Appln No. 09/729,443

Amdt date March 18, 2005

Reply to Office action of December 22, 2004

Amendments to the Drawings:

Figure #1
Prior Art

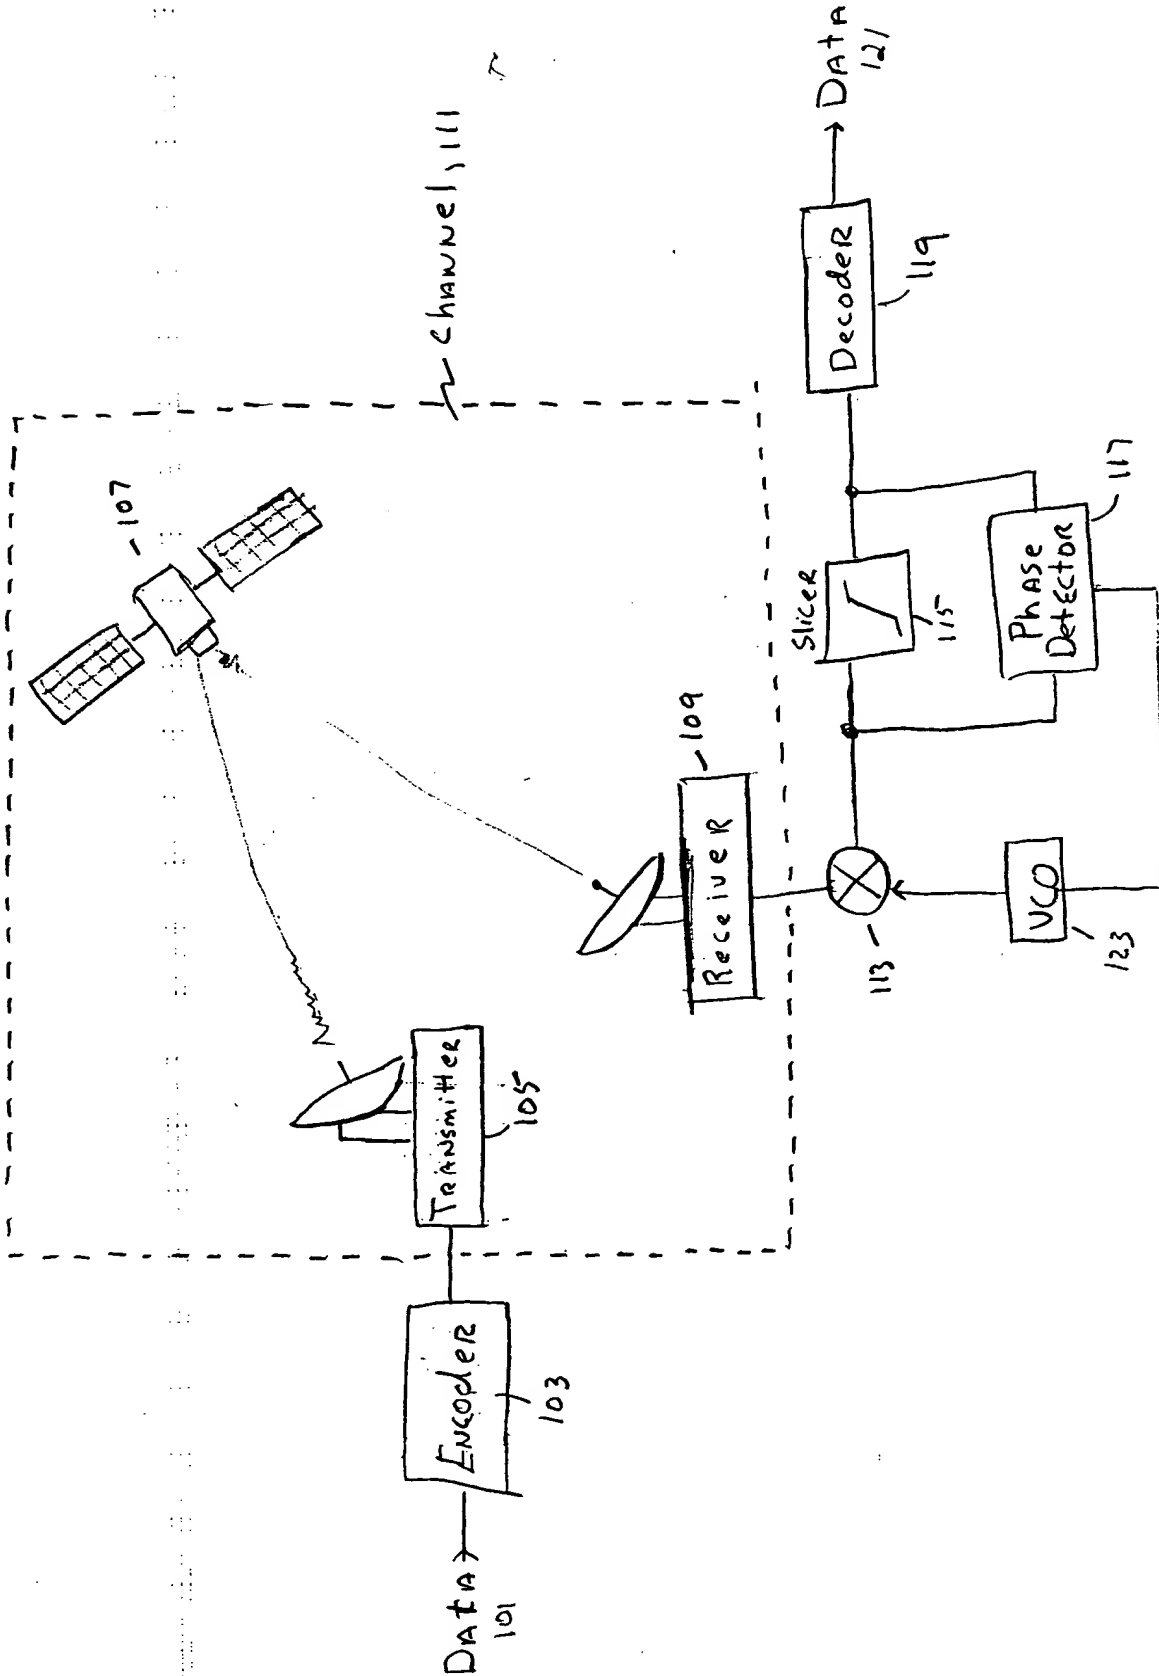
Figures 1 and 2 are objected to requiring these drawings to include a legend identifying them as "Prior Art." Figures 1 and 2 are amended and appropriately corrected drawings are enclosed. Accordingly, it is respectfully requested that the above objection be withdrawn.

The attached sheets of drawings include changes to Figs. 1 and 2. These sheets, which include Figs. 1 and 2, replace the original sheets including these figures.
